WTC DRAWING
BOOK 19
AB-1–K-1055

PROJECT: THE WORLD TRADE CENTER | TITLE: DRAWING BOOK 19 - REVISIONS AFTER FABRICATION | DATE: 5/18/73

SKILLING - HELLE - CHRISTIANSEN - ROBERTSON	Structural & Civil Engineers	
PROJECT: THE WORLD TRADE CENTER	TITLE: DRAWING BOOK 19 - REVISIONS AFTER FABRICATION - GENERAL NOTES	DATE: 8/15/68

PROJECT: THE WORLD TRADE CENTER | TITLE: REVISION AFTER FABRICATION DETAIL 904 | DATE: 8-15-68

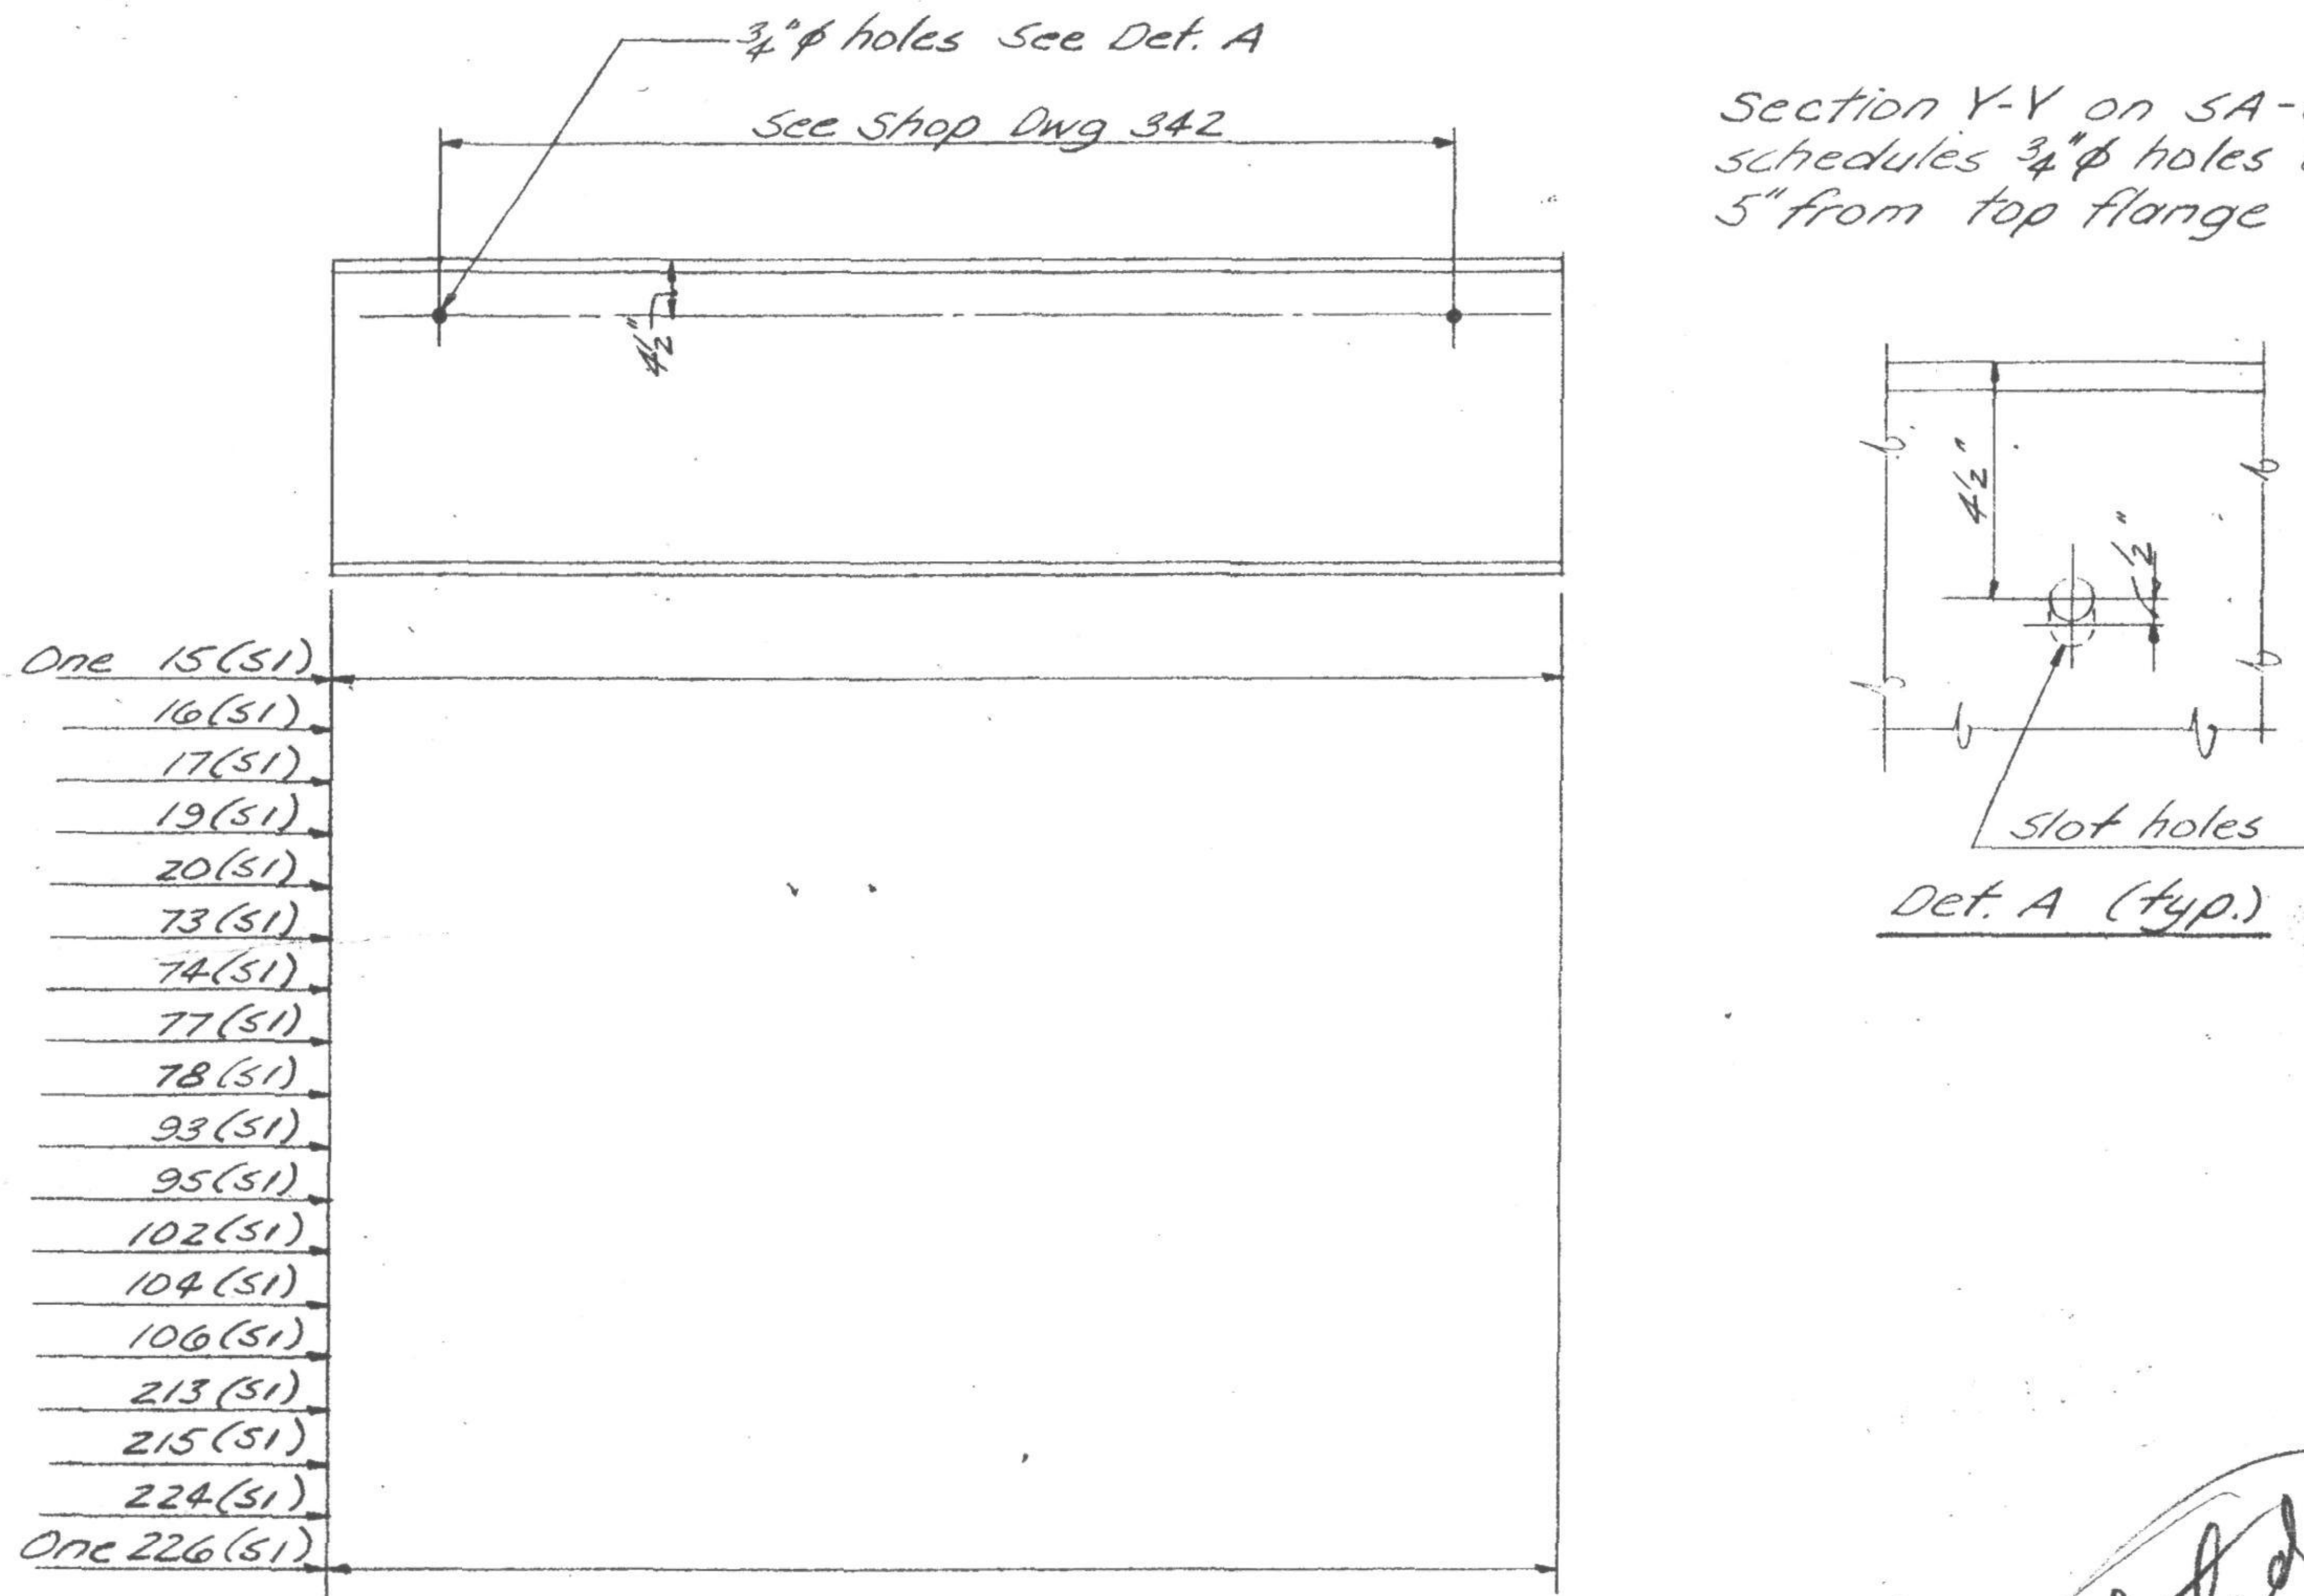
deleted per Set before 1st issue - change Slip SHCR 045 disapproved by NIL of PNYA LRB

PROJECT: THE WORLD TRADE CENTER | TITLE: REVISED BEAM CONN. TO SLURRY WALL - DETAIL H | DATE: 6-20-69

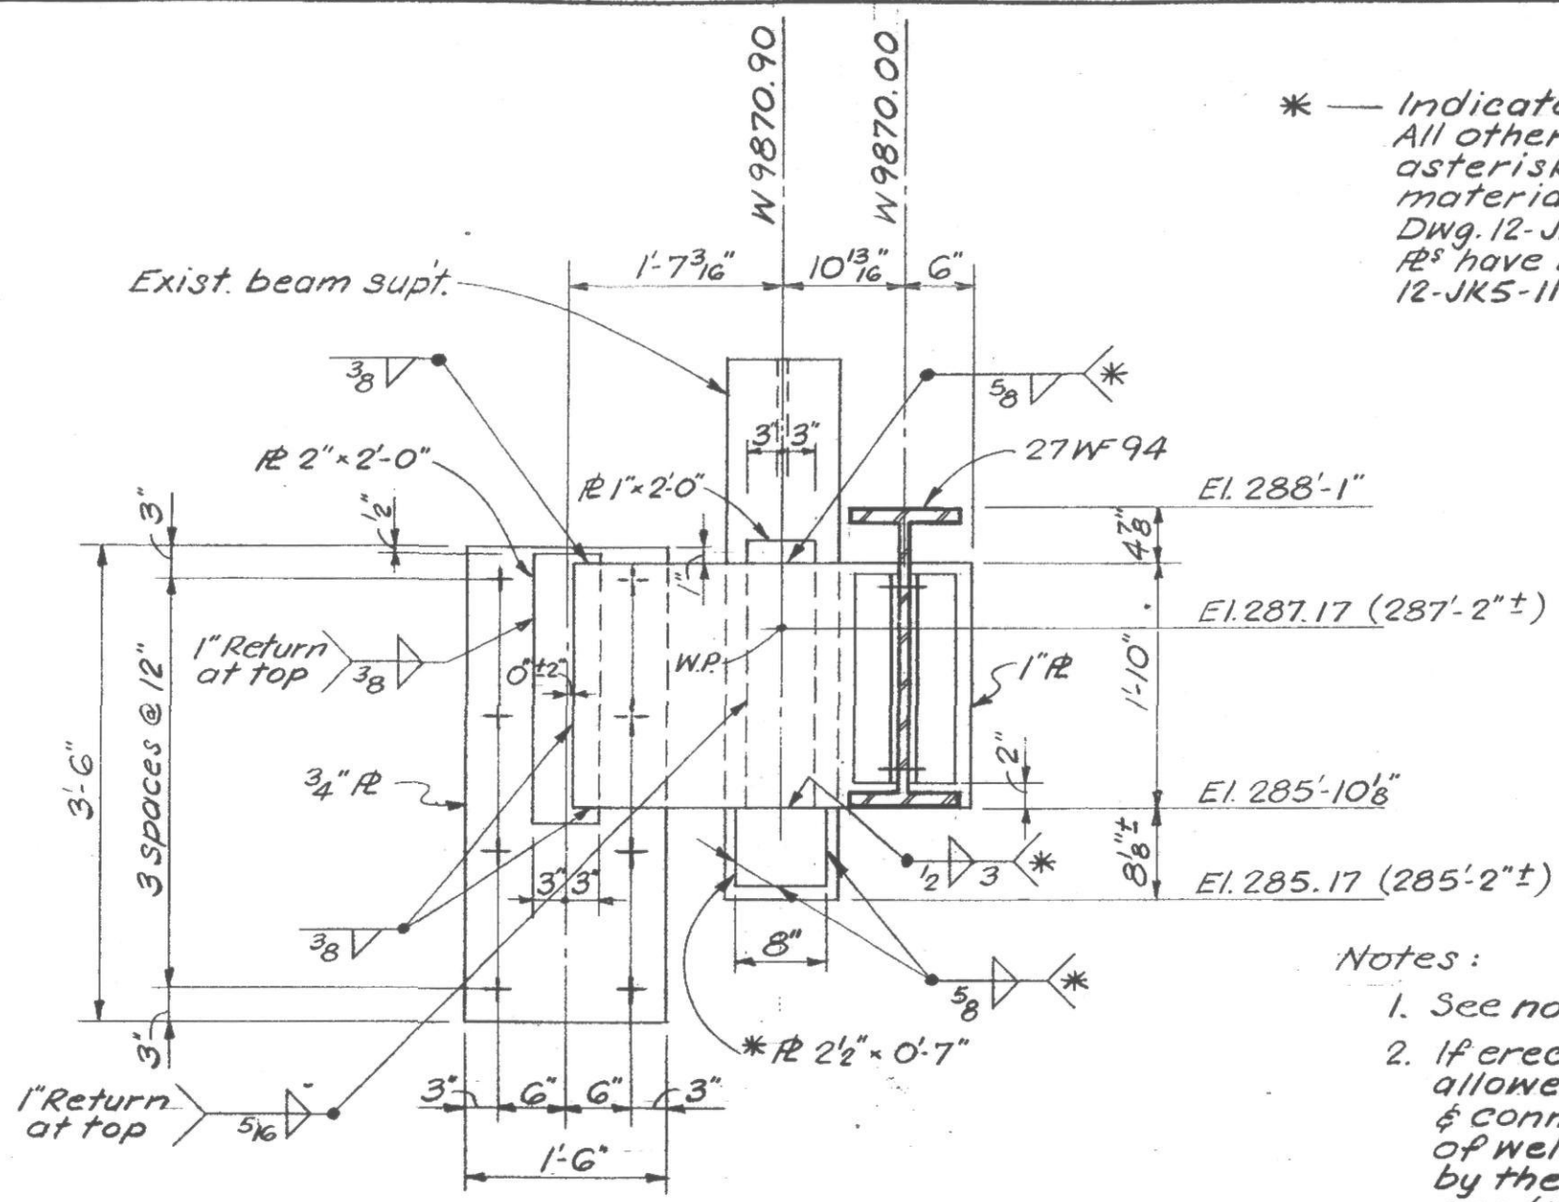
* — Indicates new PL and welds. All other items without asterisk, are existing materials as shown on Dwg. 12-JK5-11 (location of PLs have been revised from 12-JK5-11)

PROJECT: THE WORLD TRADE CENTER | TITLE: REPAIR OPENING FLOOR 7 - TOWER A - ALT.#2 | DATE: 8-7-10

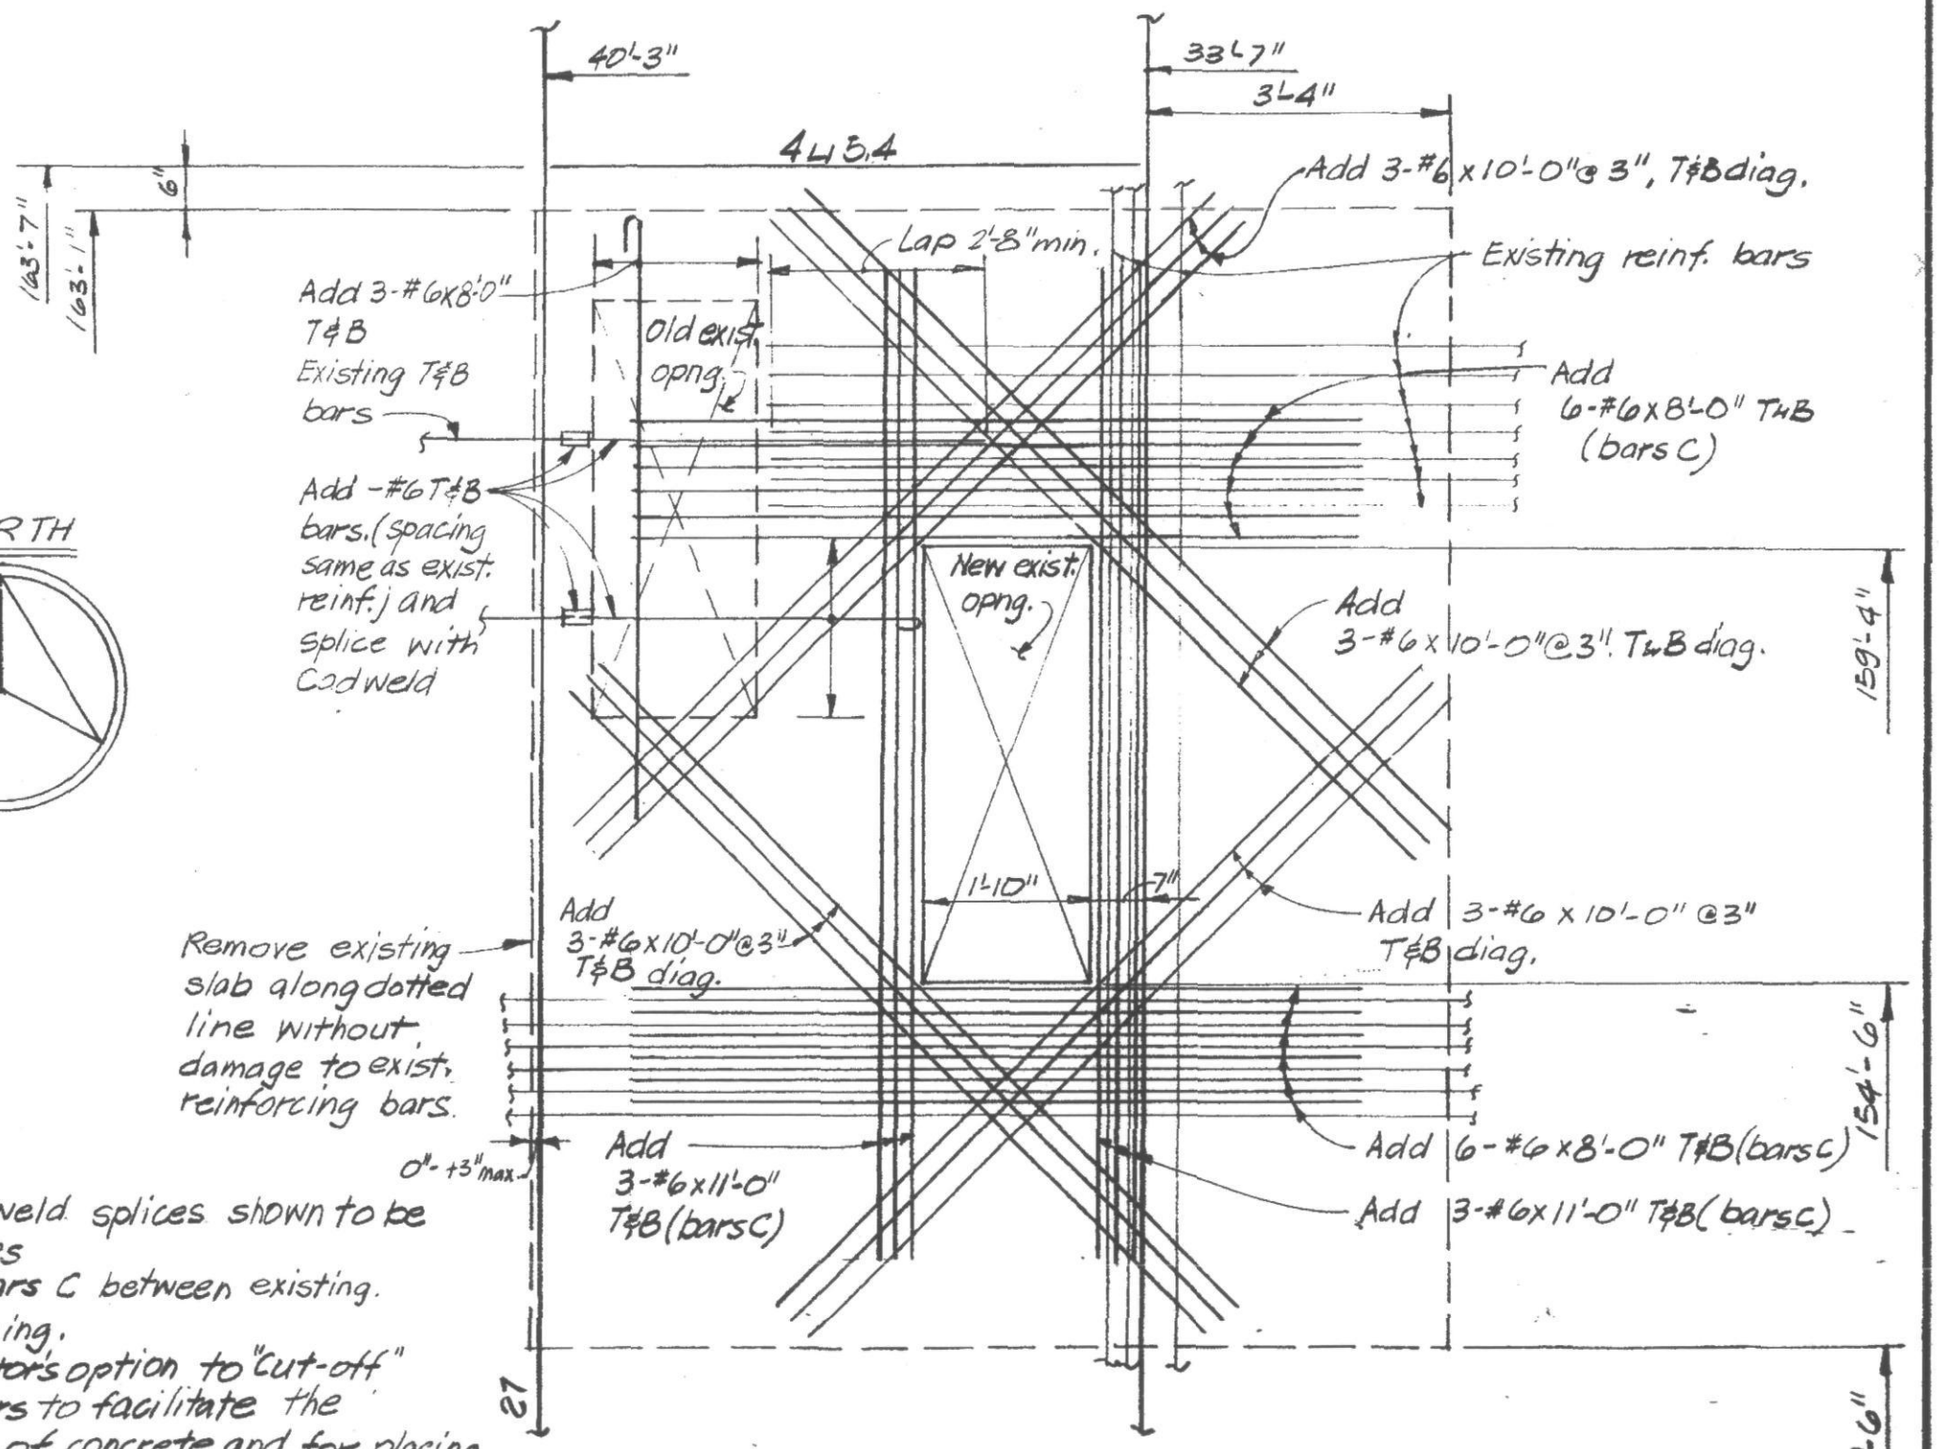
1. All Cadweld splices shown to be T-series
2. Place bars C between existing reinforcing.
3. Contractor's option to "cut-off" other bars to facilitate the removing of concrete and for placing of reinforcing however bars must be replaced and connected by Cadweld splices.
4. All concrete to be non-shrinkage with $f'_c = 4000$ psi

For opening in grating see approved pump shop dwgs.

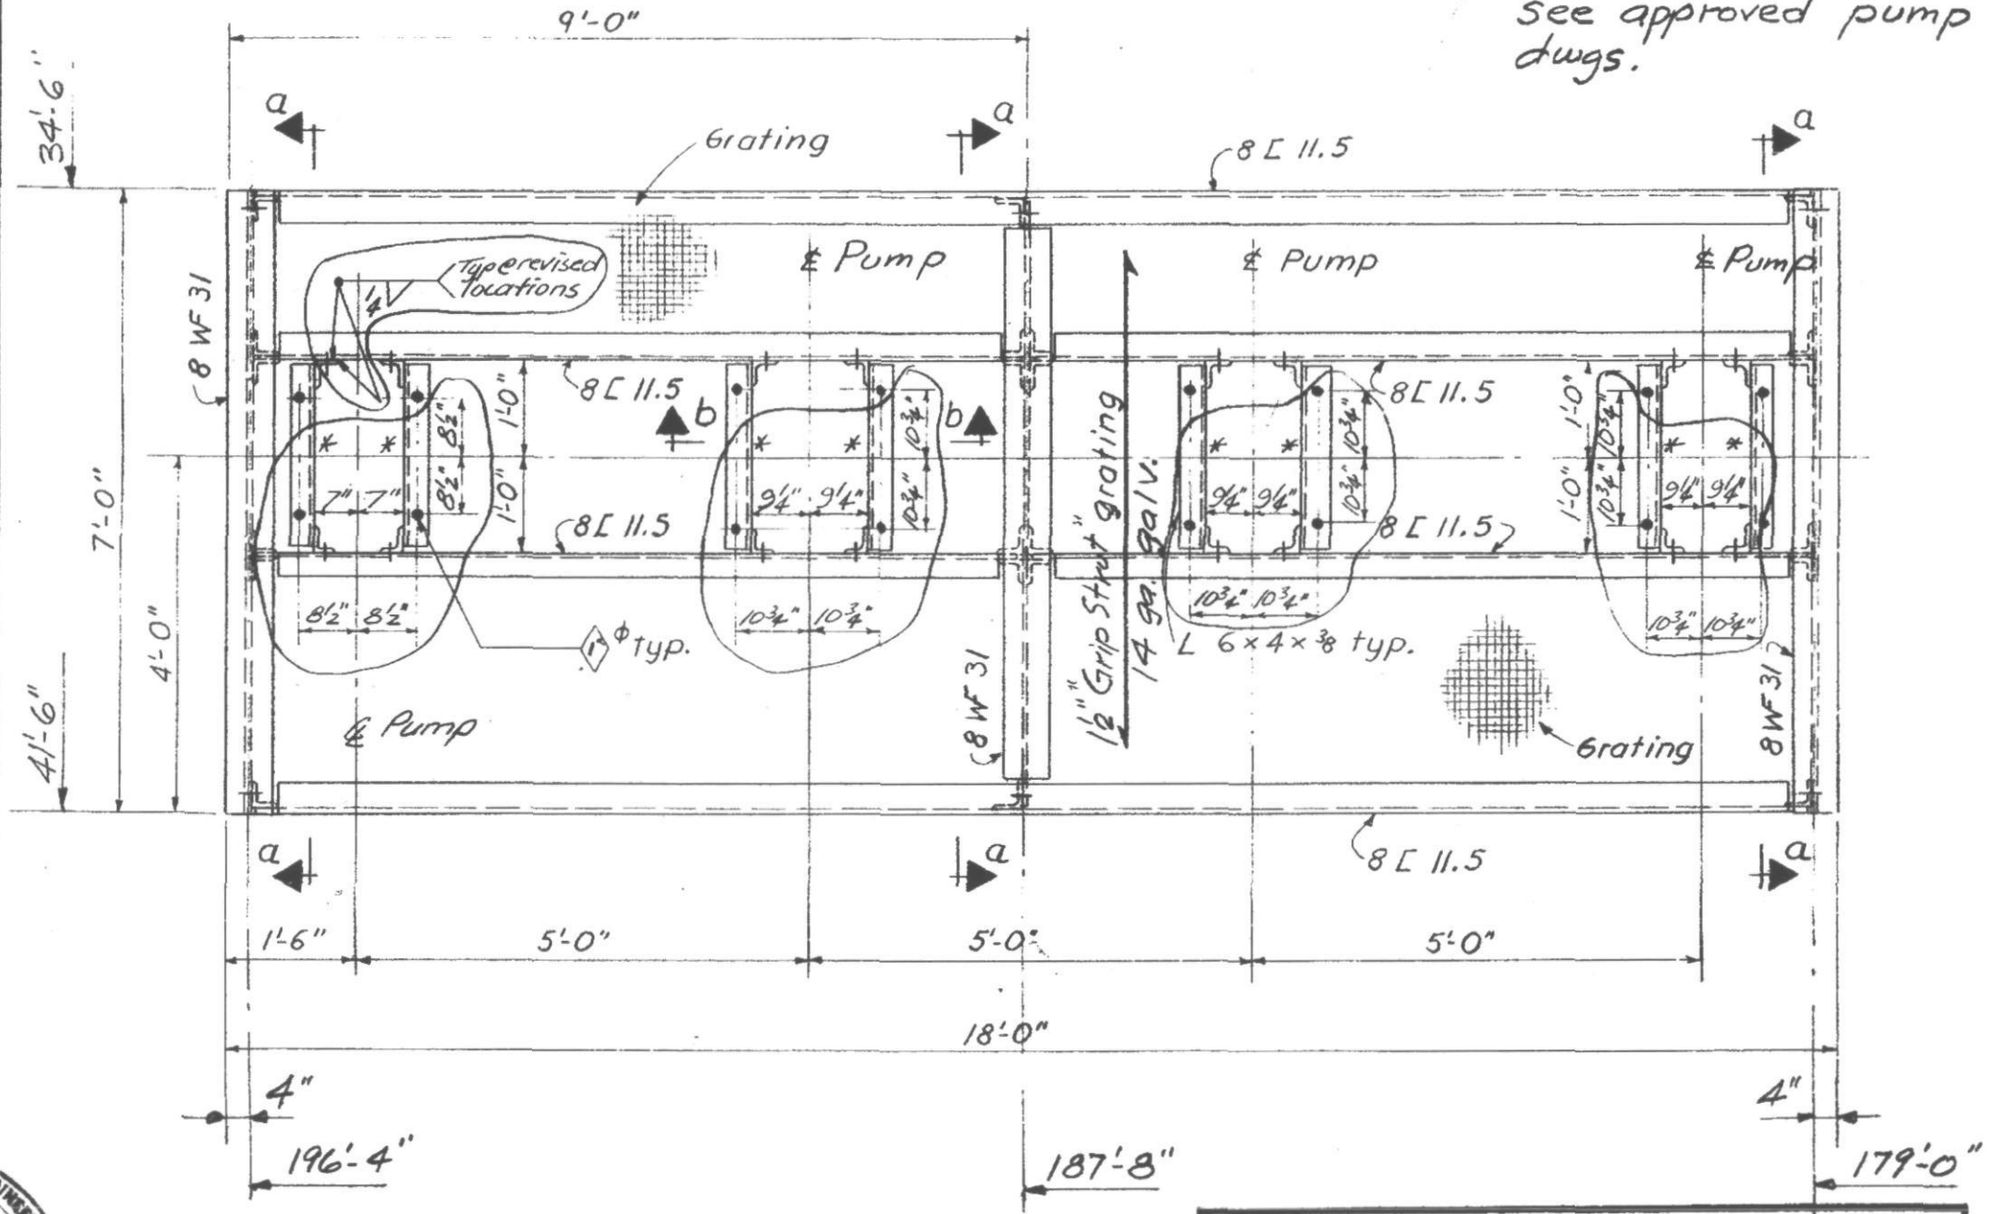
(*) Provide new 6x4x⅜ L and end clips. Connect to support Cs by field welds as shown.

(○) Revised pump bolt locations.
